## ALERT SERVICE BULLETIN

**212-21-167**

**MODEL AFFECTED:** 212

**SUBJECT:** MAIN ROTOR SCISSORS & SLEEVE HUB  
ASSEMBLY COLLECTIVE 204-011-405-013  
IDENTIFICATION

Figure 1 – Hub Assembly Ink-Stamped Part Number and Serial Number

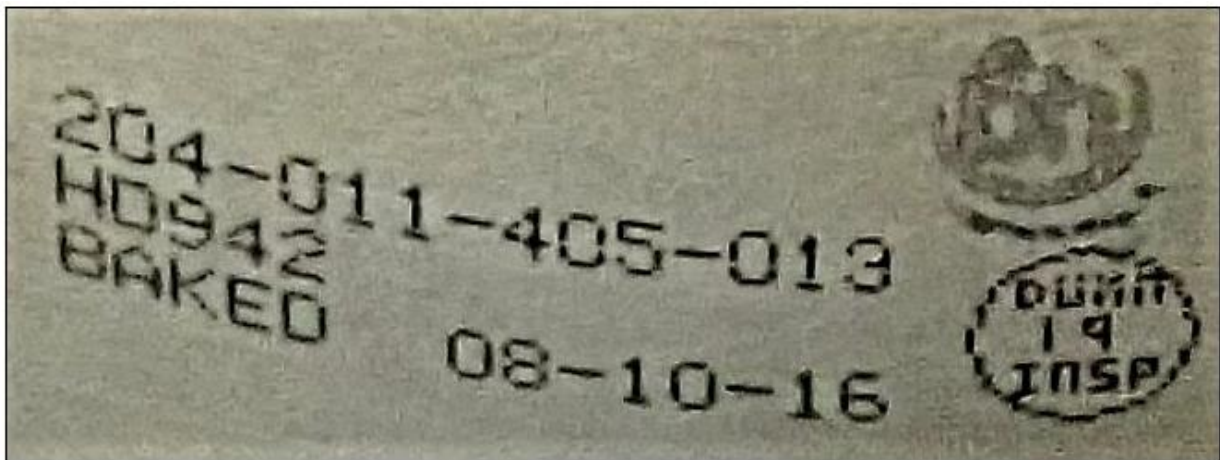
3. Gain access to the Hub Assembly 204-011-405-013 and inspect for the presence of part number and serial number matching the Historical Service Record (HSR) at the location shown on Figure 1.
4. If the Hub Assembly is not correctly marked, as shown in Figure 1, proceed with **PART II**.
5. If the Hub Assembly is correctly marked, as shown in Figure 2, make an entry in the helicopter logbook and historical service records indicating findings and compliance with **Part I** of this Alert Service Bulletin.
6. If **Part II** of this ASB is not going to be accomplished immediately, make an entry in the helicopter logbook and historical service records indicating compliance with **Part I** of this Alert Service Bulletin with an annotation to accomplish **Part II** within the required compliance time stated in this ASB.

Maximum depth of vibro-etching or dot-peening shall not exceed 0.005-inch (.127 mm). Part and serial numbers shall be marked in the scalloped area of the hub as shown in Figure 2 of this ASB; to a minimum height of 0.062-inch (1.57 mm) and no closer than 0.100-inch (2.54 mm) to any edge.

2. If the Hub Assembly has an ink-stamped part and serial number matching the HSR (refer to example shown in Figure 1), permanently mark the part and serial number on the Hub Assembly by vibro-etching or dot-peening (Figure 2).
3. If the Hub Assembly does not have a part number and serial number, create a unique serial number for each Hub Assembly. Using one or two prefix letters consistent with the company name of the operator or repair facility accompanied by a dash and 4 or 5 digits is considered as an industry serial number marking standard. Vibro-etch or dot-peen the Hub Assy with the part number and the assigned serial number (Figure 2).
